ADDENDUM NO. 02

68th/ Simonds Restriping and NE 170th Sidewalk Improvement Project

Bid No. 24-C3028

Friday April 19, 2024

CH04

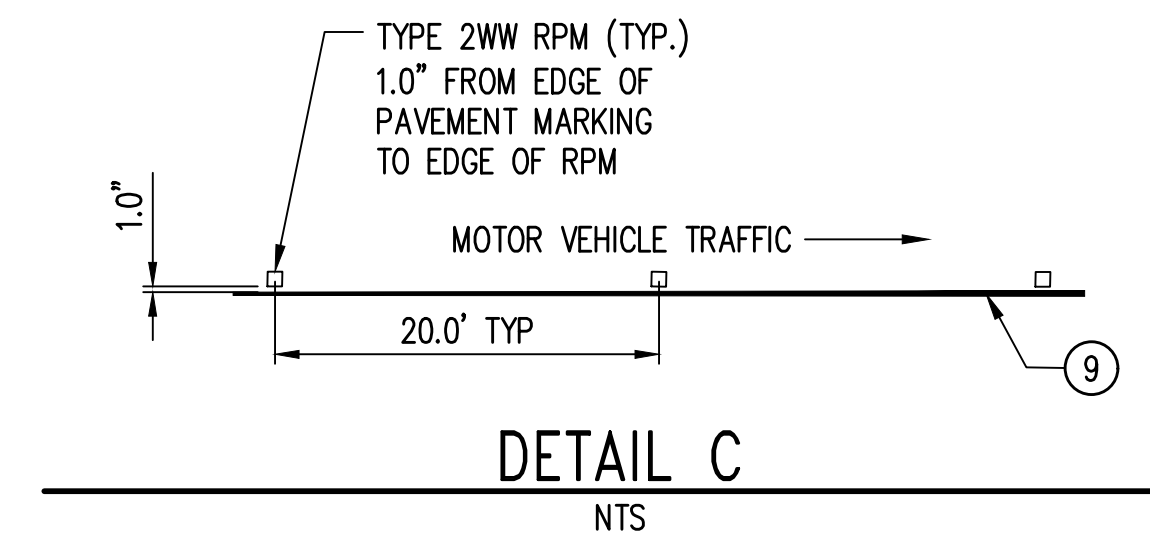
1. Call For Bids: Bid due date changed to April 24, 2024 at 2:00pm. (2 pages)
2. Bid Submittal Checklist: Bid Signature page added (1 page)
3. Bid Proposal Sheets (7 Pages)
 - a. Quantity change on Item A6. Uniformed Police Officer.
 - b. NE 170th Sidewalk bid items have been moved to Schedule B.
 - c. Schedule B Item number format changed to B1, B2, etc...
 - d. Quantity change on B29. (formerly A52) Plastic Wide Line.
 - e. Quantity change on B30. (formerly A53) Plastic Stop Line.
 - f. Quantity change on B37. (formerly A60) Green MMA Bike Lane
 - g. New item: B38. Plastic Crosswalk
 - h. Bid Signature Page: Working days changed to 60 Days.
4. Appendix D: Traffic Control Plan. (2 pages)
5. Plans sheets changes: CH04, CHD01, SGN, SG1, SG2, SG3. (6 pages)

1	04/16/24	170TH & JUANITA INTERSECTION	CJO	NDA
No	Date	Revision	By	Appr

CHD01

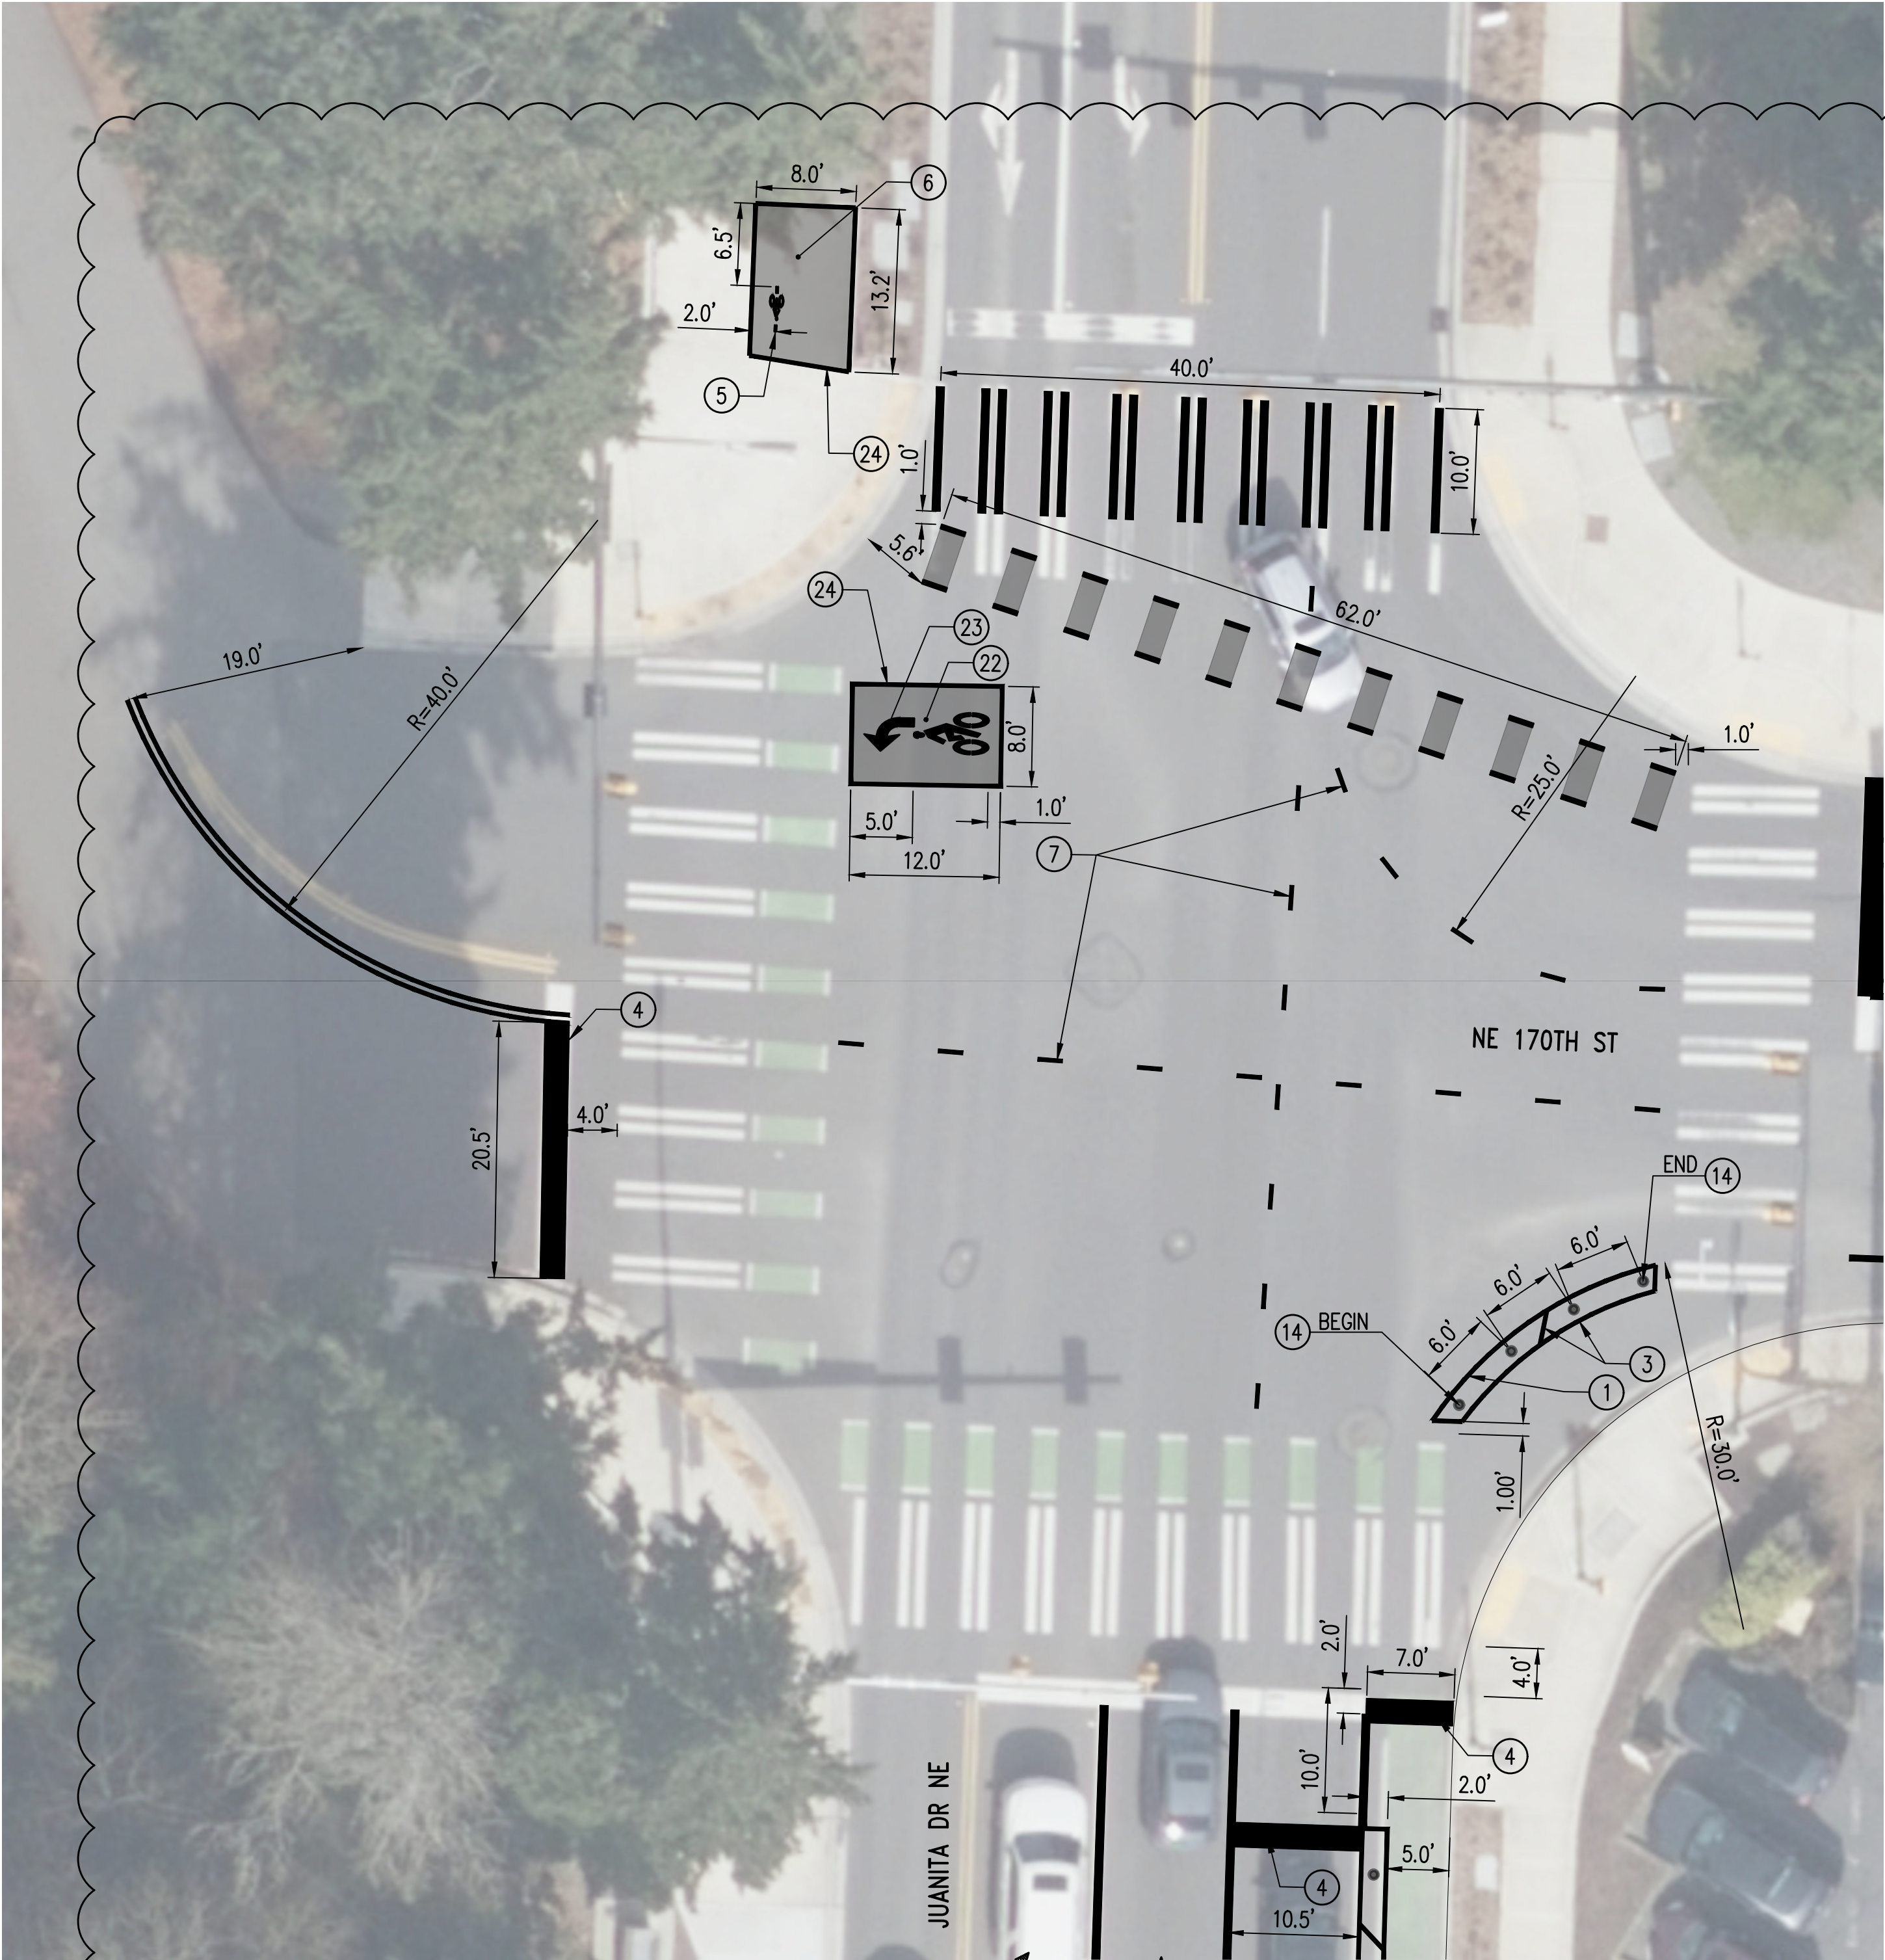
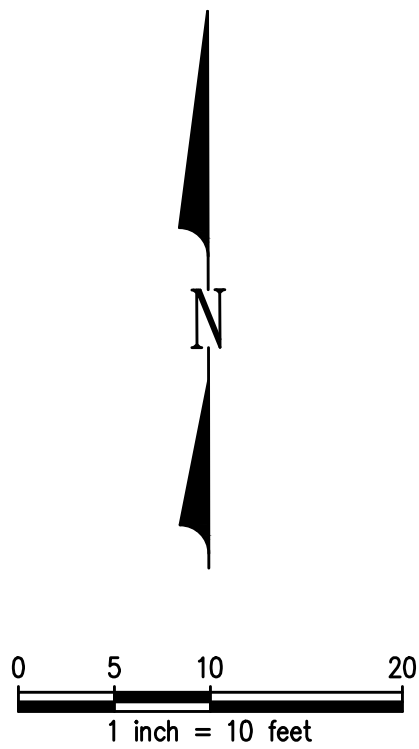
1	04/16/24	170TH & JUANITA INTERSECTION	CJO	NDA
No	Date	Revision	By	Appr

SHEET 32 of 37
SGN
SCALE: NTS

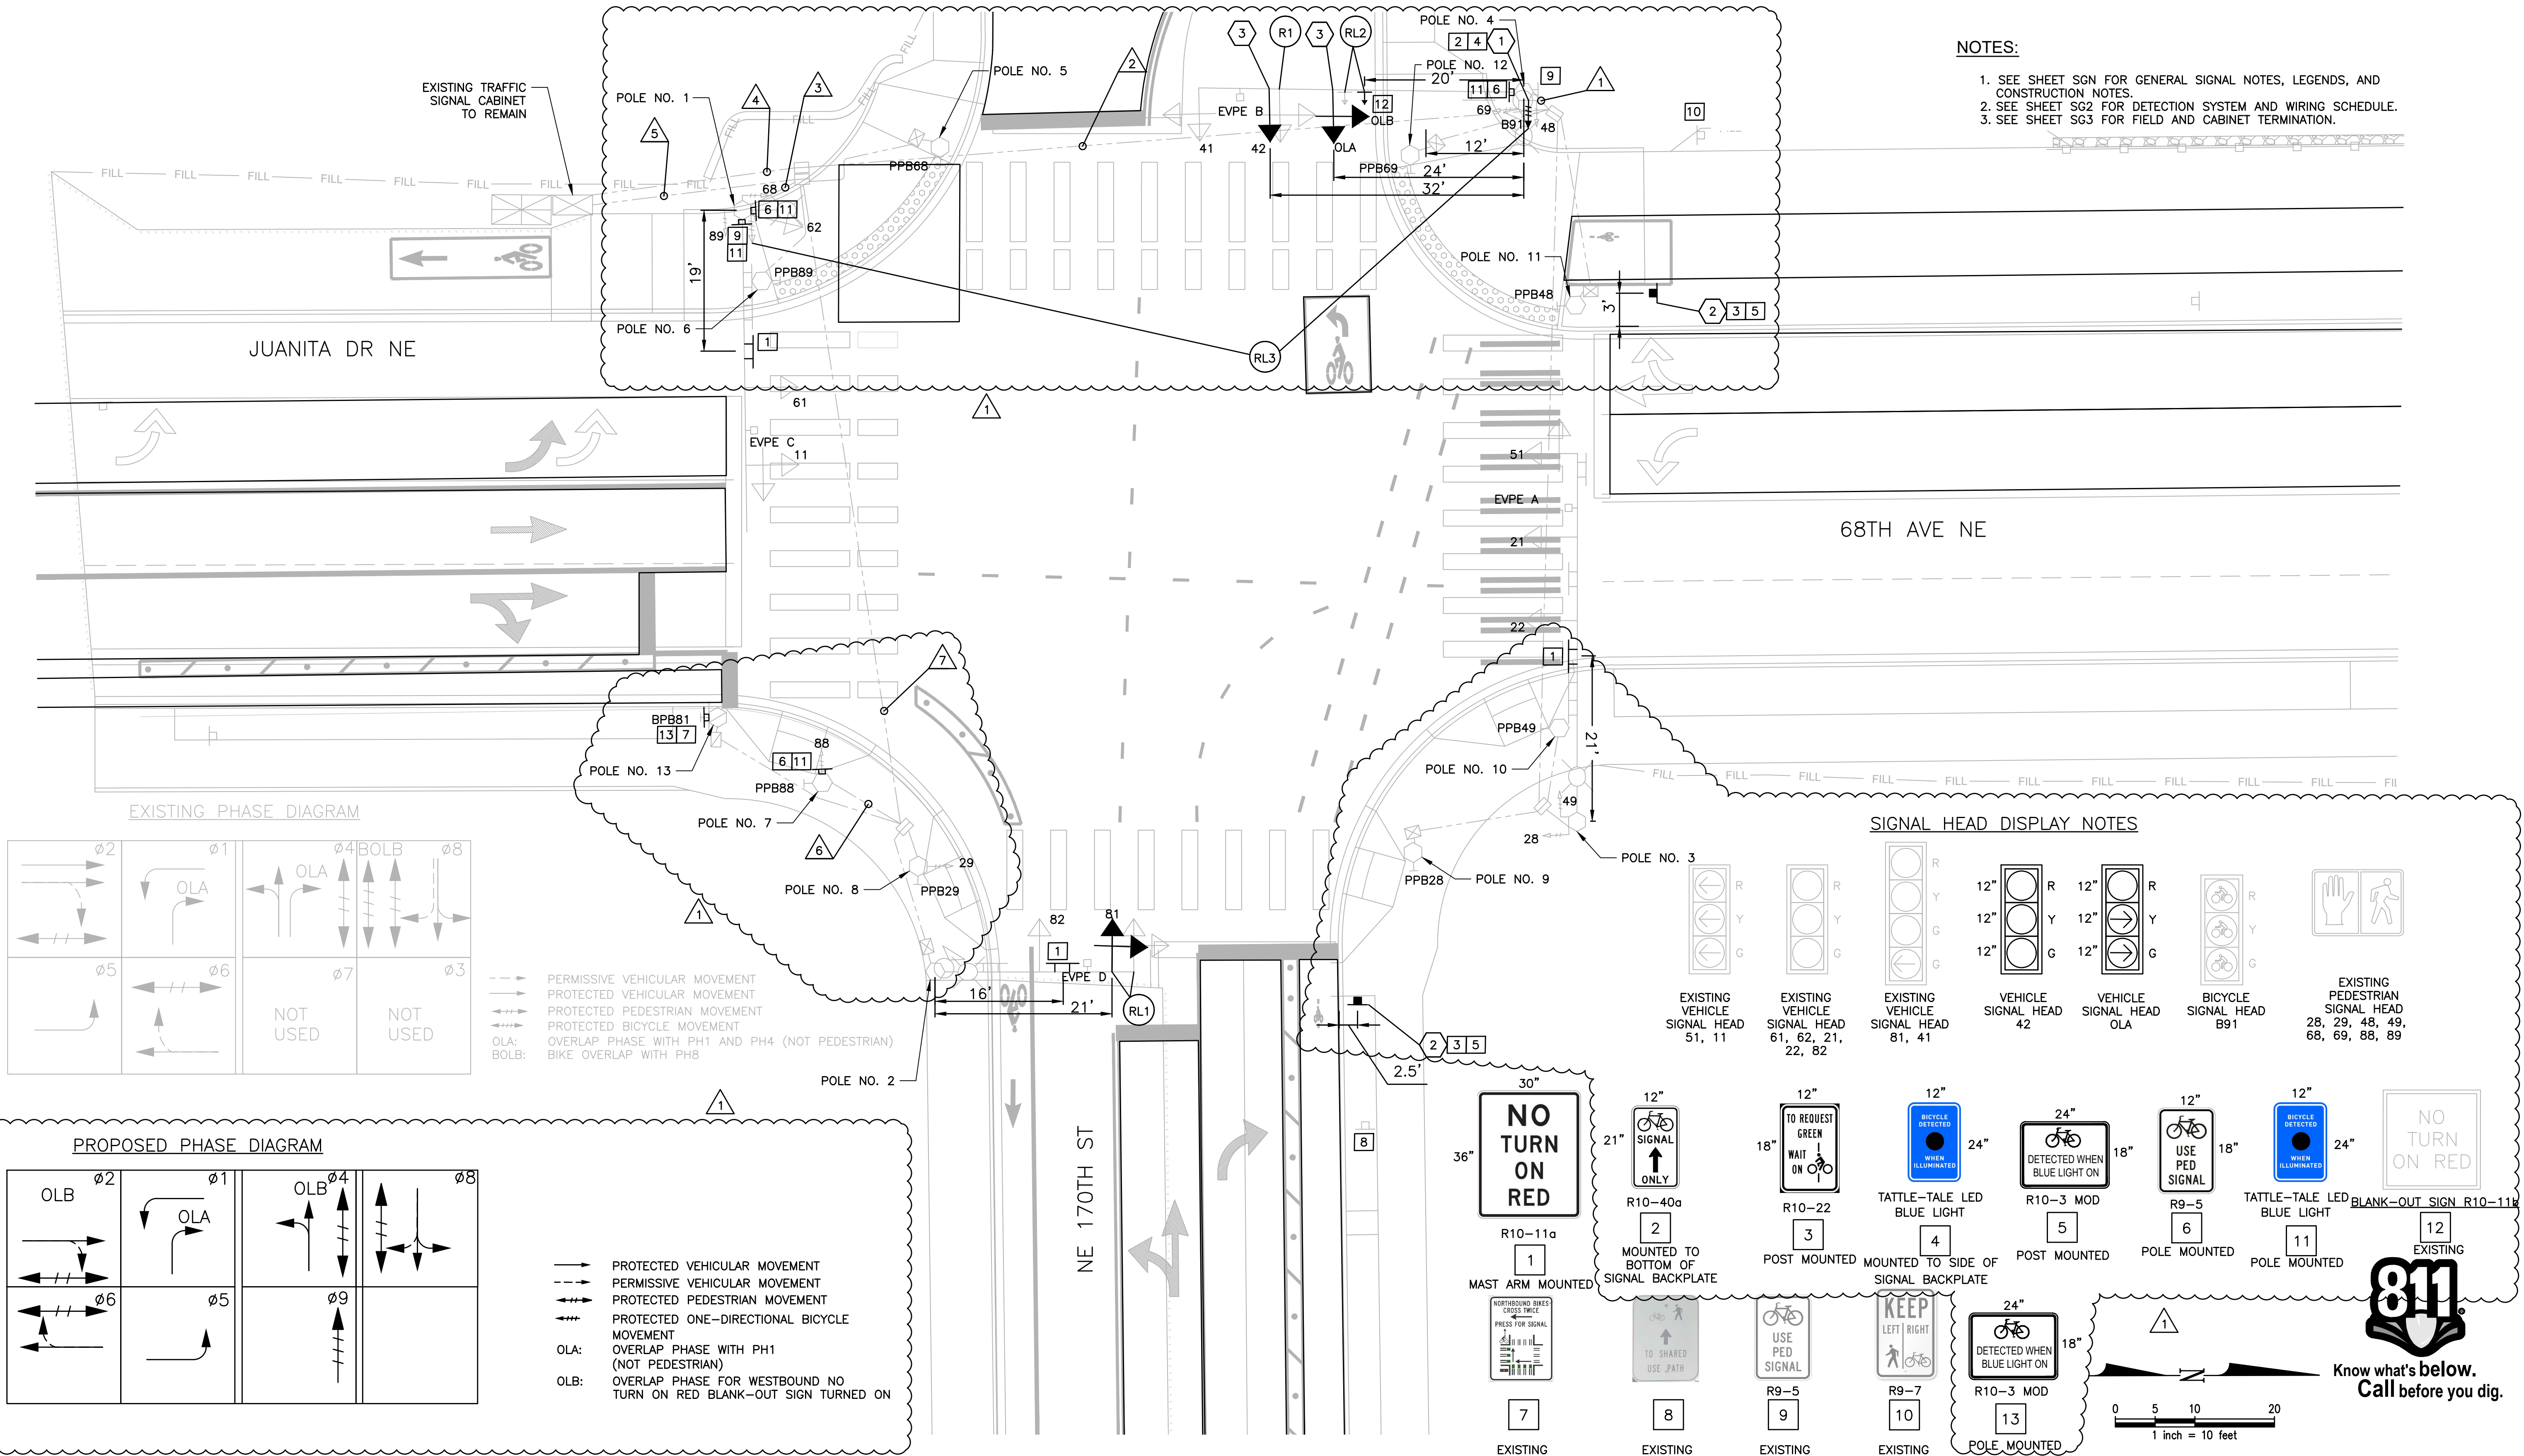
4/19/24	170TH & JUANITA INTERSECTION		
No	Date	Revision	By	Appr
